**Response Letter**

Comments Issued: January 11, 2021  
Project: DePaul – TC Morgan Hill Venture (Redwood Tech at 101)  
Address: Cochran Rd and Highway 101  
Application #: SR2020-0029, SR2020-0030, SR2020-0031, SR2020-0032, SR2020-0033, SR2020-0011

RE: Design Review and Completeness Comments

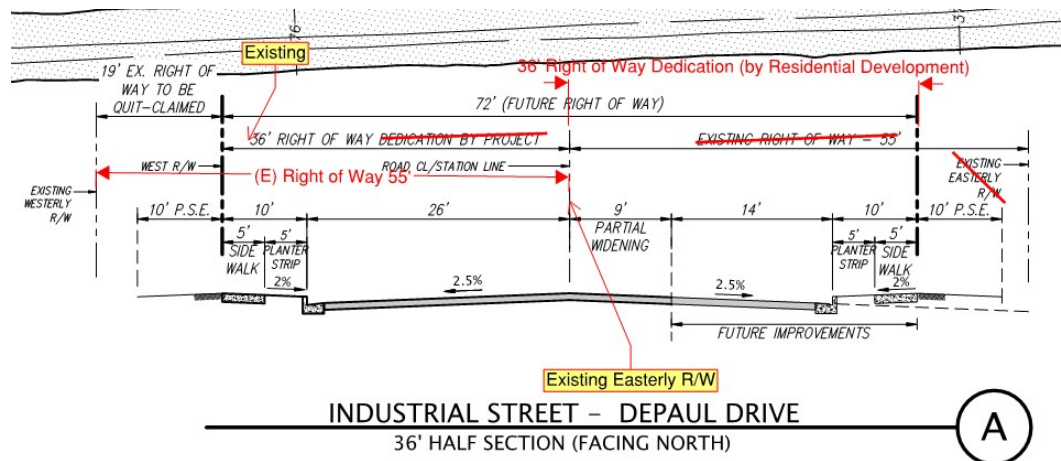
2. On Sheet 2, the two proposed right-of-way callouts on the plan for De Paul Drive reference the incorrect section ‘B’; revise the callout to reference section ‘A’.

**Response: The callouts to sections on Sheet 2 have been revised.**

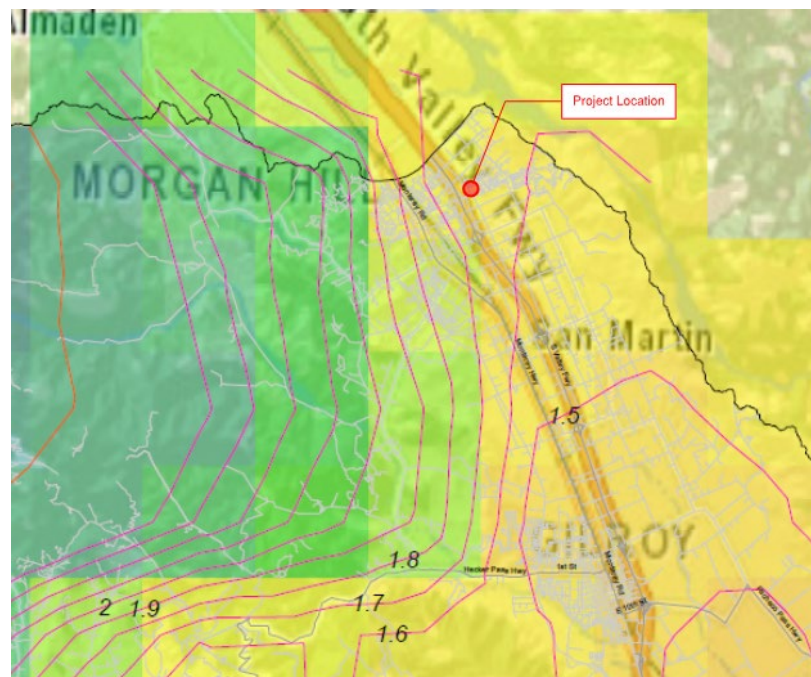
- 1) Include a discussion in the report of how the underdrain functions and connects to the storm drain system.

**Response: Discussion included in the report in section IV. Stormwater Control Approach of updated report.**
